UNITED STATES PATENT AND TRADEMARK OFFICE

Office Action Summary	Application No. 10/590,638	Applicant(s) RAMSAUER, DIETER	
	Examiner KRISTINA R. FULTON	Art Unit 3673

DETAILED ACTION

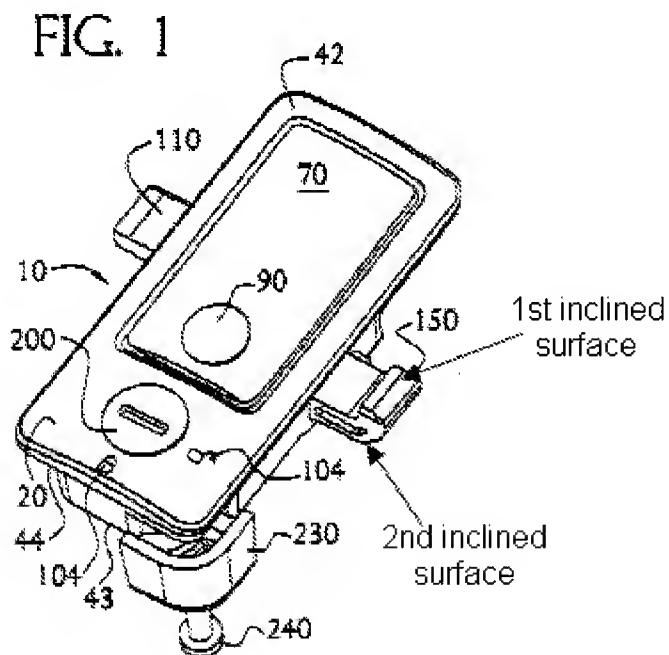
8. Claims 28-29, 31 and 34 are rejected under 35 U.S.C. 102(b) as being anticipated by Vickers (US 6145352).

9. Regarding claims 28, 31 and 34, Vickers teaches a latch having a head part (42) arranged outside a thin wall, a body part (20 below 42) which proceeds from the head part and projects through the opening in the mounted position, holding elements (110 and 150) which project from the body part and are displaceable in a direction, a free end of the holding elements being provided with an inclined surface (see figure below) for supporting the body part without play on the rim and said free end of said holding

elements being further provided with a second inclined surface (see below) for slam action, wherein the holding elements are slides that diametrically oppose each other; the inclined surfaces at approximately at right angles to each other; the body part and the holding elements being separate parts and the holding elements being slides.

Please note "as best understood" for the last limitation of claims 28 and 31 and claim 34, Vickers shows a lock cylinder (200) associated with holding elements (110 and 150). If applicant intends to call the head part of the cylinder then please note that applicant's "cylinder" is as much as cylinder as Vickers 10 shown in figure 1.

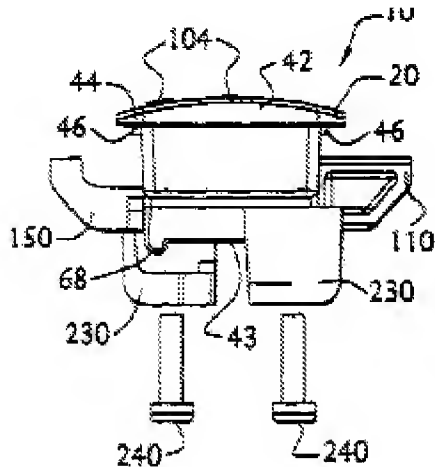
11. Regarding claim 31, Vickers teaches the claimed limitations as applied to claim 28 above and further teaches "as best understood" that a slides are held by a spring force (198) and a pin arrangement (tabs and slots of figures 9 and 10). See the Vickers device below.
